Access Compliance Report

Public Rights-of-Way

Intersection ID: 11692	Main Street: GREEN_APPLE_DR	Cross Street: SUNCREST_CT	Location: NW
ADA ID: 53FA79148E8E	Ramp Type: Perp	Initial Pass/Fail: Fail	Overall Compliance: No
		Severity Score: 60

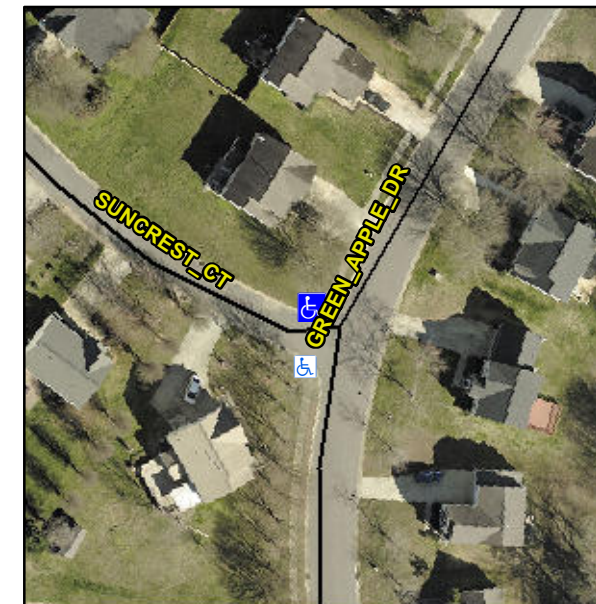
Not Found, R304.5.1, R304.2.2, R304.5.3

Compliance	Description	Data	Compliance	Description	Data
N/A	Ramp Length (in)	94.0	No	Ramp Slope (%)	10.8
No	Ramp Width (in)	27.0	No	Ramp XSlope (%)	5.2
N/A	Flare Type LT	N/A	N/A	Flare Type RT	N/A
N/A	Flare Slope LT (%)	N/A	N/A	Flare Slope RT (%)	N/A
N/A	Flare Traversable LT?	N/A	N/A	Flare Traversable RT?	N/A
N/A	Landing Length (in)	N/A	N/A	DWS Provided?	N/A
N/A	Landing Width (in)	N/A	N/A	DWS Contrast?	N/A
N/A	Landing Slope (%)	N/A	N/A	DWS Length (in)	N/A
N/A	Landing X Slope (%)	N/A	N/A	DWS Full Width?	N/A
N/A	Landing Curb? (Y/N)	N/A	N/A	DWS Offset (in)	N/A
N/A	Shared Landing?	N/A			
N/A	Gutter Ponding?	N/A	N/A	Gutter Slope (%)	N/A
N/A	Gutter Lip Ht (in)	N/A	N/A	Gutter X Slope (%)	N/A
N/A	Painted X Walk1?	No	N/A	Painted X Walk2?	N/A
	X Walk 1 Direction	To S		X Walk 2 Direction	N/A
N/A	X Walk 1 Width (in)	N/A	N/A	X Walk 2 Width (in)	N/A
	X Walk 1 Slope (%)	2.9		X Walk 2 Slope (%)	N/A
	X Walk 1 X Slope (%)	1.9		X Walk 2 X Slope (%)	N/A

Remove & Replace Entire Ramp.
